Access Compliance Report Public Rights-of-Way (Curb Ramps)

Intersection ID: 28095Main Street:PROVIDENCE_RD_WESTCross Street: GLENFINNAN_DRLocation:NADA ID: 1149945B5D11Ramp Type:PerpInitial Pass/Fail:FailOverall Compliance: NoSeverity Score:42.5

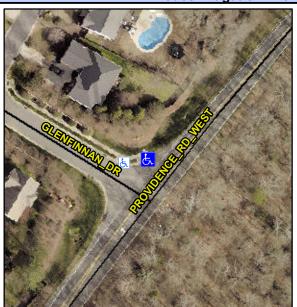
R304.5.1, R304.5.3

Field Measurements/Component Compliance					
Compl	iance Description	Data	Comp	liance Description	Data
N/A	Ramp Length (in)	96.0	Yes	Ramp Slope (%)	5.2
No	Ramp Width (in)	34.5	No	Ramp XSlope (%)	8.6
N/A	Flare Type LT	N/A	N/A	Flare Type RT	N/A
N/A	Flare Slope LT (%)	N/A	N/A	Flare Slope RT (%)	N/A
N/A	Flare Traversable LT?	N/A	N/A	Flare Traversable RT?	N/A
N/A	Landing Length (in)	N/A	N/A	DWS Provided?	N/A
N/A	Landing Width (in)	N/A	N/A	DWS Contrast?	N/A
N/A	Landing Slope (%)	N/A	N/A	DWS Length (in)	N/A
N/A	Landing X Slope (%)	N/A	N/A	DWS Full Width?	N/A
N/A	Landing Curb? (Y/N)	N/A	N/A	DWS Offset (in)	N/A
N/A	Shared Landing?	N/A			
N/A	Gutter Ponding?	N/A	N/A	Gutter Slope (%)	N/A
N/A	Gutter Lip Ht (in)	0.5	N/A	Gutter X Slope (%)	N/A
N/A	Painted X Walk1?	No	N/A	Painted X Walk2?	N/A
	X Walk 1 Direction	To SE		X Walk 2 Direction	N/A
N/A	X Walk 1 Width (in)	N/A	N/A	X Walk 2 Width (in)	N/A
	X Walk 1 Slope (%)	6.0		X Walk 2 Slope (%)	N/A

Remove & Replace Entire Ramp.
